Village of Arlington Heights
Plan Commission
Board Room
Arlington Heights Village Hall
33 S. Arlington Heights Road
Arlington Heights, IL 60005
June 10, 2015
7:30 PM

To: Plan Commission
Prepared By: Latika Bhide, Development Planner
Meeting Date: June 10, 2015
Date Prepared: June 4, 2015
Project Title: Northwest Metalcraft
Address: 413 S. Arlington Heights Road

Northwest Metalcraft
413 S. Arlington Heights Road
Prepared by: The Village of Arlington Heights
Department of Planning & Community Development
January 2015

UTILITY PLAN / GRADING PLAN
NORTHWEST METALCRAFT
ARLINGTON HEIGHTS, ILLINOIS
Project Manager: M L A
Engineer: J A C
Date: 12/04/2014
Project No. 13-144
Sheet 2

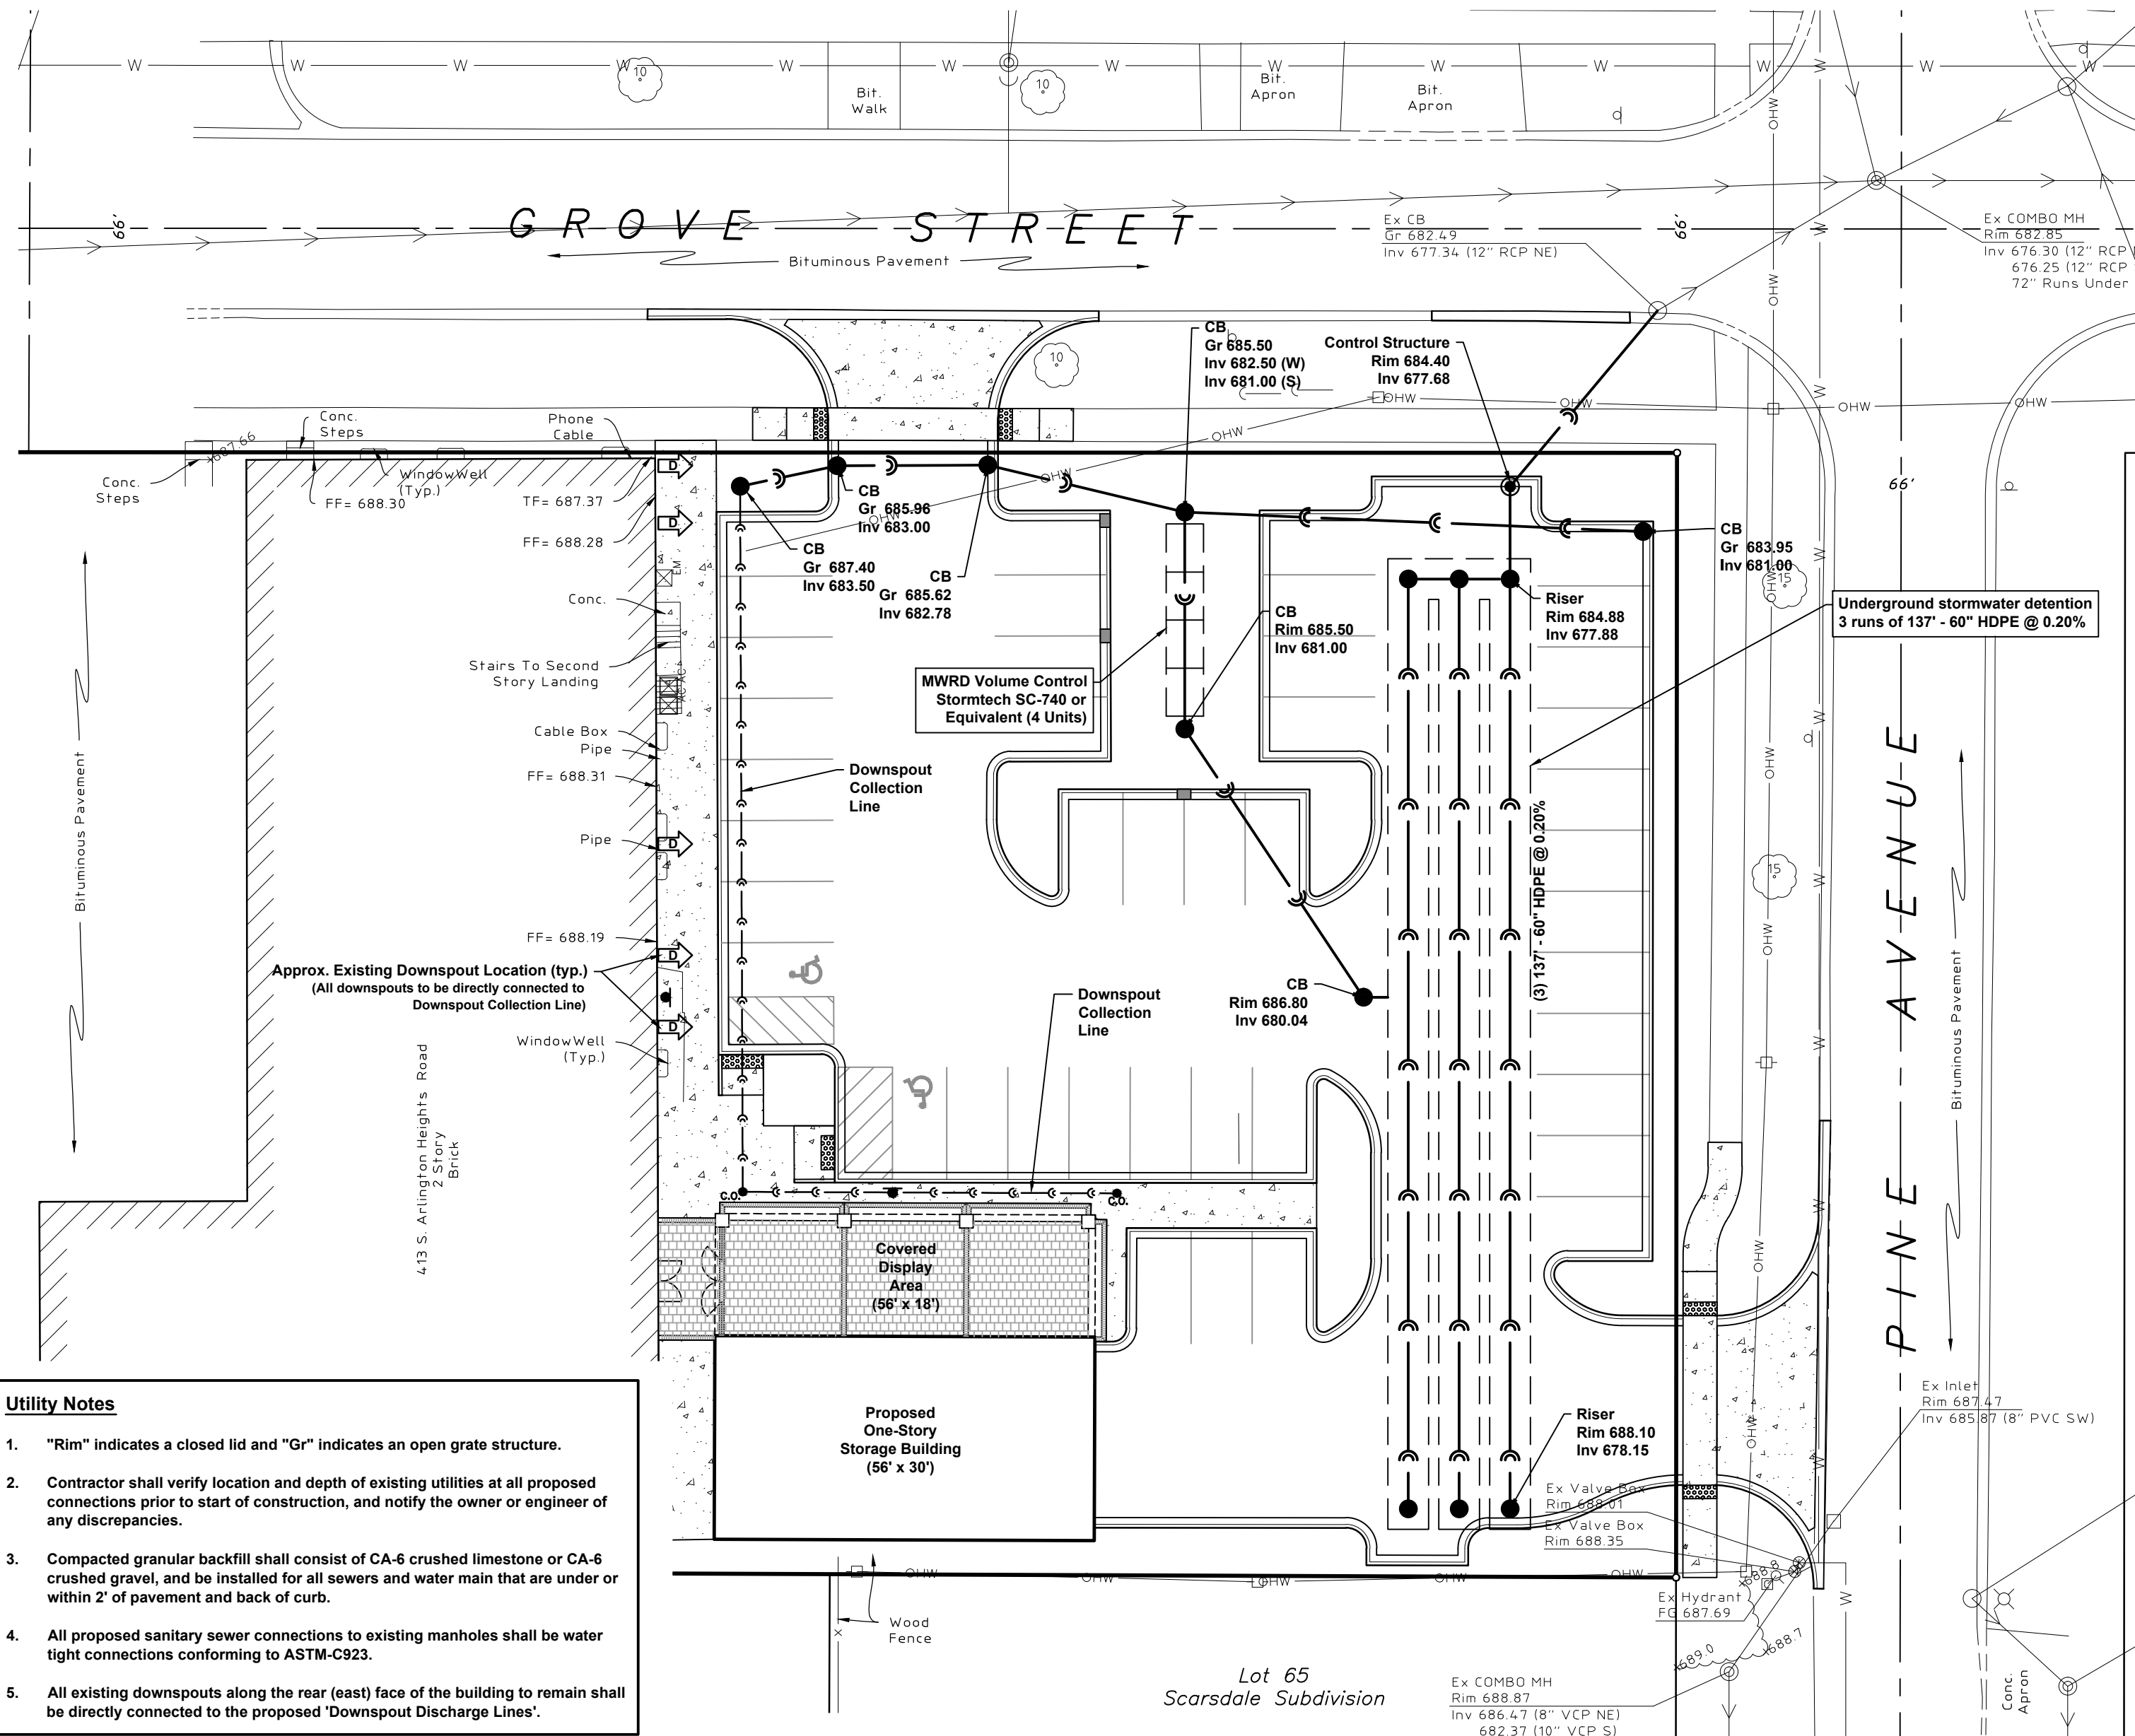
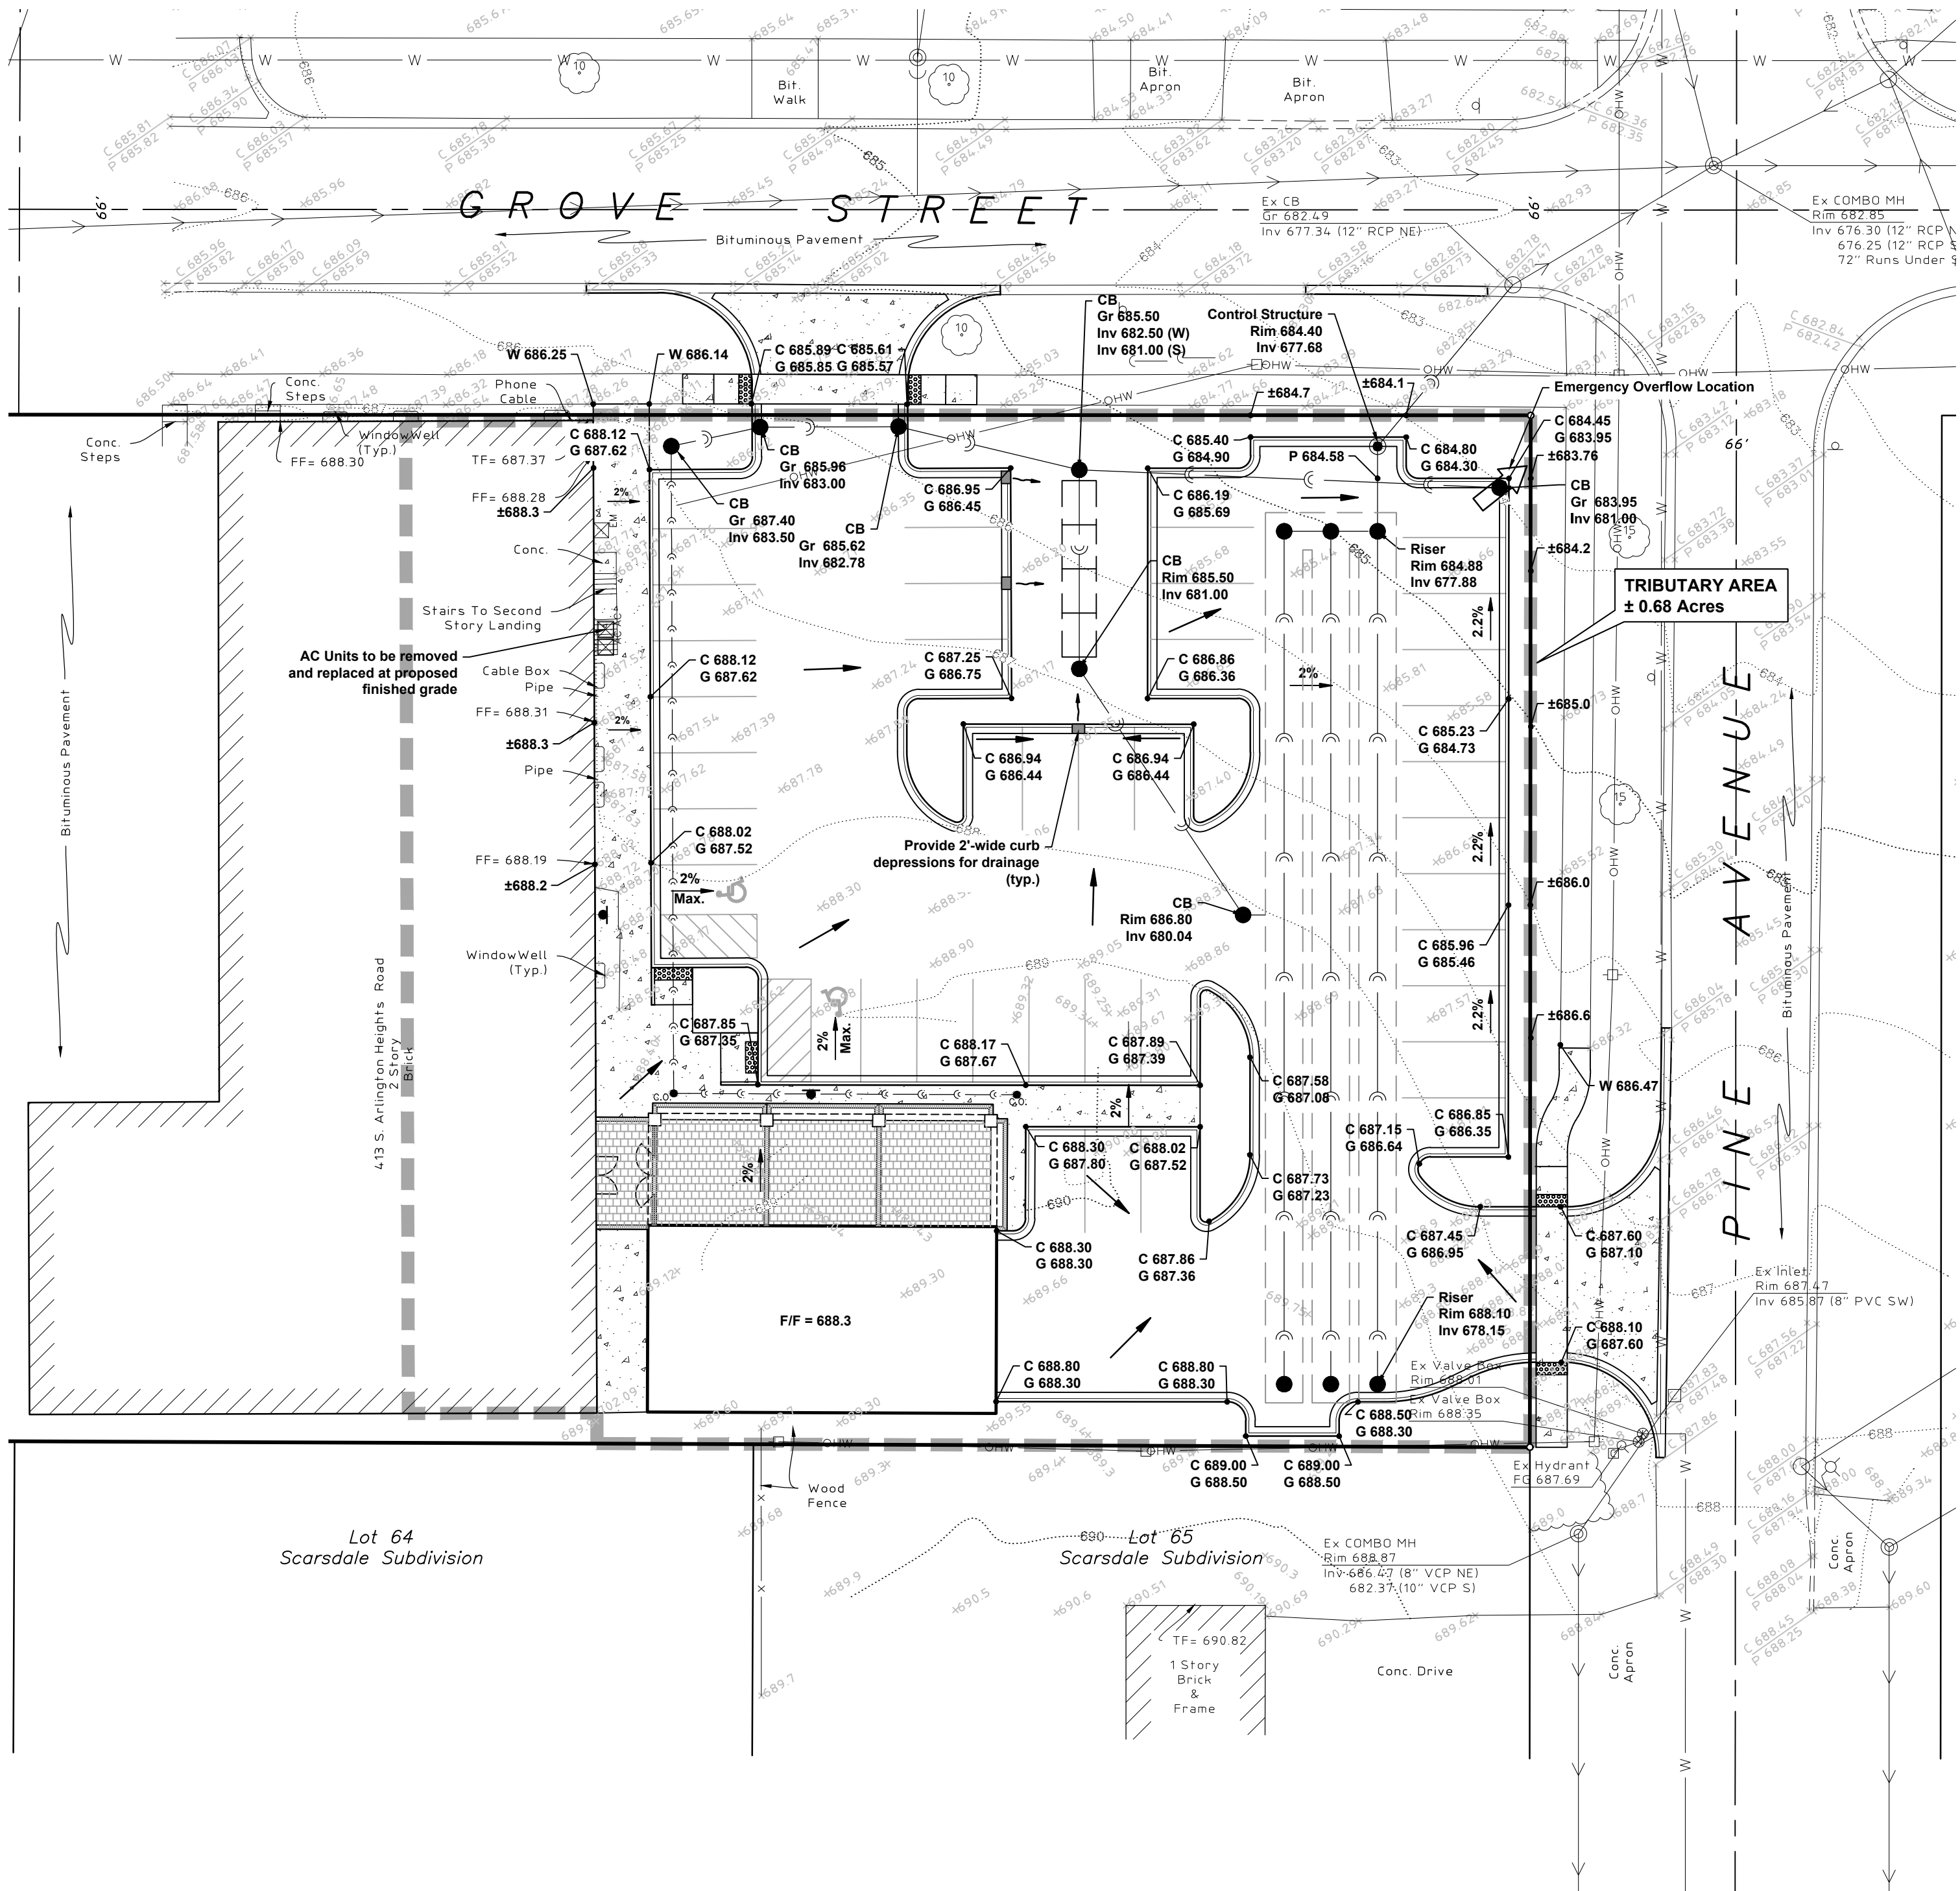
25. *Show where the existing building downspouts drain. As many as possible should be routed...*
Approximate locations for the existing downspouts along the rear face of the building have been added to the Utility Plan on Sheet 2 of the civil plans. A new 'Downspout Collection Line' has also been added to collect and route these downspouts to the proposed detention system.
